Access Compliance Report Public Rights-of-Way (Pedestrian Signals)

Main Street: **S_HEWES_ST** Cross Street: **CHAPMAN_AVE** Location: **SW**

ADA ID: **SGAT210929132411** Signal Type: **One Push Button-Non APS** Overall Compliance: **No** Severity Scores: **BTN 1: 35** **BTN 2: N/A** **No BTN: N/A**

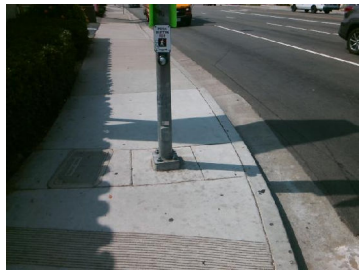
OC Std/PROW: **R404.2, R404.3, MUTCD 4e.08**

Possible Solutions: Replace Signal Push Button With APS Button. Remove and Replace Clear Space.
